Comment on the Wooing Tree Estate project

Waka Kotahi NZ Transport Agency (Waka Kotahi) understand the application is for a subdivision to create 300 residential sites and three business superlots for business development including a neighbourhood centre and travellers' accommodation, and the creation of 18 lots for the purpose of vested roads and park lands. The proposed project work will occur at Wooing Tree Estate, 64 Shortcut Road, corner of State Highway 6 (SH6) and State Highway 8B (SH8B), Cromwell, Otago. Access to the development site is to be via a new roundabout to be formed on SH8B at the existing intersection with Barry Avenue.

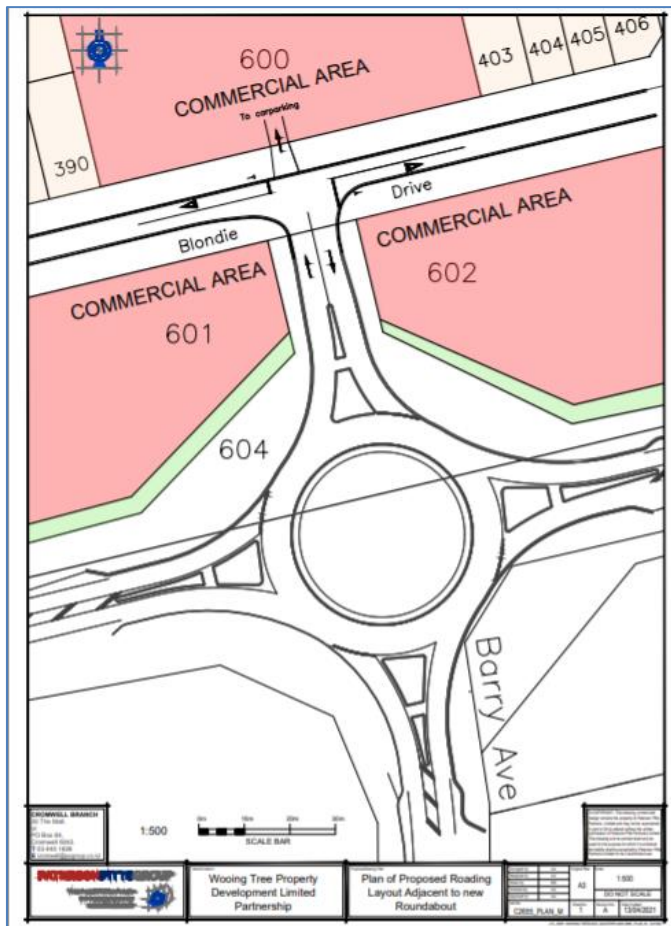
The application as lodged appears to include a number of potential roading layouts for how the internal intersection between Blondie Drive and the commercial area (Lot 600) will work. Diagram 6 of the application, which is also the Commercial Precinct Connectivity Plan in the Urban Design Report at Attachment B, shows the commercial shared area including this intersection as having two-way traffic on all limbs as below.

This layout is different from the Barry Ave Intersection Plan in Attachment O of the application, which indicates traffic will be restricted to one-way entry into the commercial shared area. As a result, we have assumed the more up to date plan “the one-way version” as below is the layout the applicant is proposing.

There are also no clear plans of how pedestrians and cyclists will move from the underpass to the commercial area and how they will safely cross Blondie Ave at this intersection. This is discussed in more detail below.

The location of this intersection close to the roundabout and how it is proposed to work is of concern to Waka Kotahi. These concerns are covered in more detail below. However, we would note the application as lodged does not provide enough information and the information provided is contradictory on how this crucial intersection will operate.

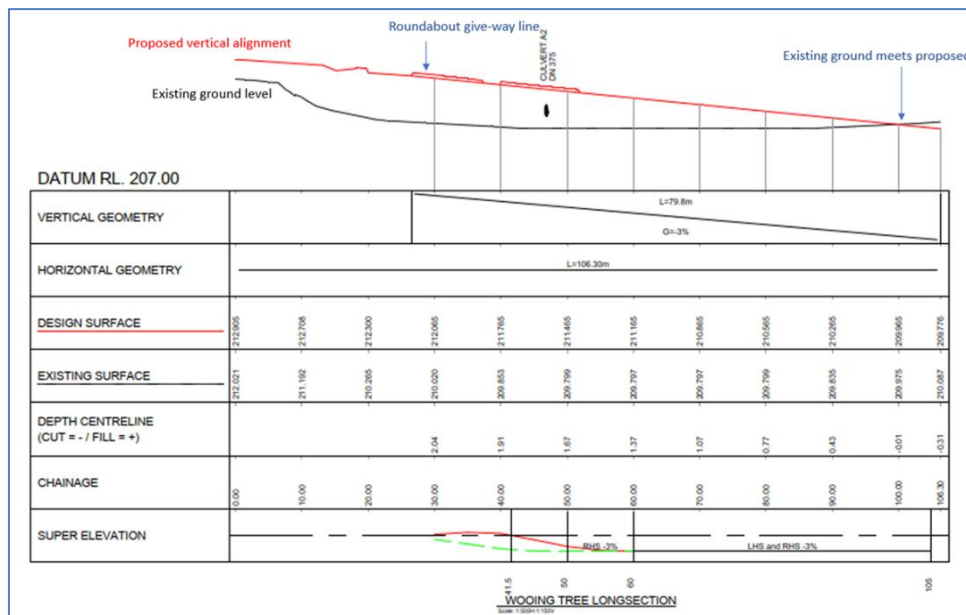
- a. Priority: The priority of the traffic coming from the roundabout is important as the main access into the site. Therefore, the first link from the roundabout to the internal intersection will carry the majority of traffic (compared to all the other arms at the first internal intersection), and it should be classified as the major link and be the main priority at this first intersection to avoid any queuing back into the roundabout. This priority should continue onto the link towards Shortcut Road, so that
 - i) this is indicated as a desirable connector link as already signalled in the district plan, and

- ii) to remove any traffic on the inbound link (from the roundabout to the first internal intersection) requiring to give-way to other traffic at the intersection (i.e. to prevent traffic queues back towards the roundabout). Although attachment G of the application (Transportation Assessment) has assessed the queues on this approach to the first intersection are minimal (95th percentile queue of 2 vehicles) should the link give-way to Blondie Drive, on occasion queues will be greater and may consist of four coaches and other larger vehicles – this reduces the Sight Stopping Distance (SSD) to below the required distance to enable a normally alert driver, travelling at the design speed on wet pavement to perceive and brake to a stop before reaching a hazard, which is around 40 m for a 40kph speed. Therefore, the short inbound link between the roundabout and the first internal intersection at around a length of 45m, introduces a critical road safety concern in terms of drivers exiting from the roundabout having insufficient notice of any downstream queues on this link.

- b. Although the configuration as shown in Attachment O of the application provides an amended priority arrangement that gives priority to the inbound link, the intersection is shown as having a sharp 90-degree bend which is not desirable from both a safety and operational sense. It is therefore difficult to see how priority can be achieved in a safe way without a significant change to the internal road structure and/or alignment.

- x. *The intersection with Blondie Drive and the SH8B/Barry Avenue roundabout shall be designed to provide priority to vehicles travelling from the roundabout towards Shortcut Road.*
- xx. *Prior to the commencement of construction works described in Condition x, the consent holder must provide detailed designs of the Blondie Drive intersection to the Central Otago District Council Manager Transportation Asset Manager for technical review and certification.*
- xxx. *As part of the information submitted in Condition xx, correspondence from the NZ Transport Agency shall be provided confirming that the proposed works meet with the agreement of the NZ Transport Agency.*
